Urgent Notification Regarding Use of Pre-Lace Hoisting Grip

Date: 27 January 2023
Location: HUBER+SUHNER AG; Herisau; Switzerland
Department: COM FO Technology and Operations Product Management
Contact: Sebastian Hofmann
Addressees: all customers
Page: 1 of 5

Urgent Notice regarding product variant Masterline Classic Hybrid 12x24 / Masterline Classic Power 12

Working Instruction

Figure 1: Visualization

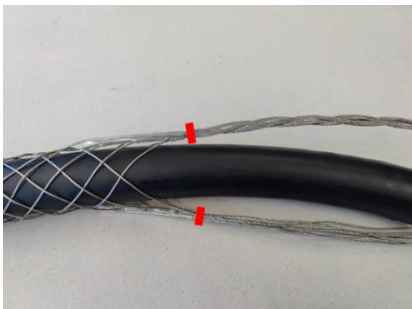
The assembly must be carefully unpacked and the portion of the cable where the Pre-Lace Hoisting Grip is attached to the cable must be made accessible.

The stickers and labels are reused in the final packaging, so they must be kept undamaged until step 4.

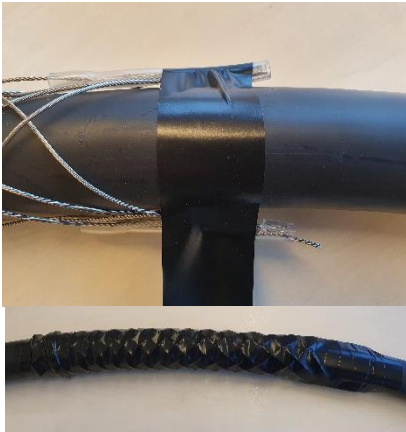
Cut off the pull loop beyond the mesh (both sides) with a wire rope cutter at the indicated locations above the plastic protection.

Attention: The cable jacket must not be damaged in any way.

3.		<p>Wrap and completely cover the rest of the Pre-Lace Hoisting Grip with the tape.</p>  <p>No wires of the Pre-Lace Hoisting Grip should protrude, as they could snag or injure people during installation. The wrapping tape should form a smooth surface.</p>
4.		<p>Upon completion of the above steps, the entire assembly (incl. wooden spool) should be covered with plastic wrap.</p>
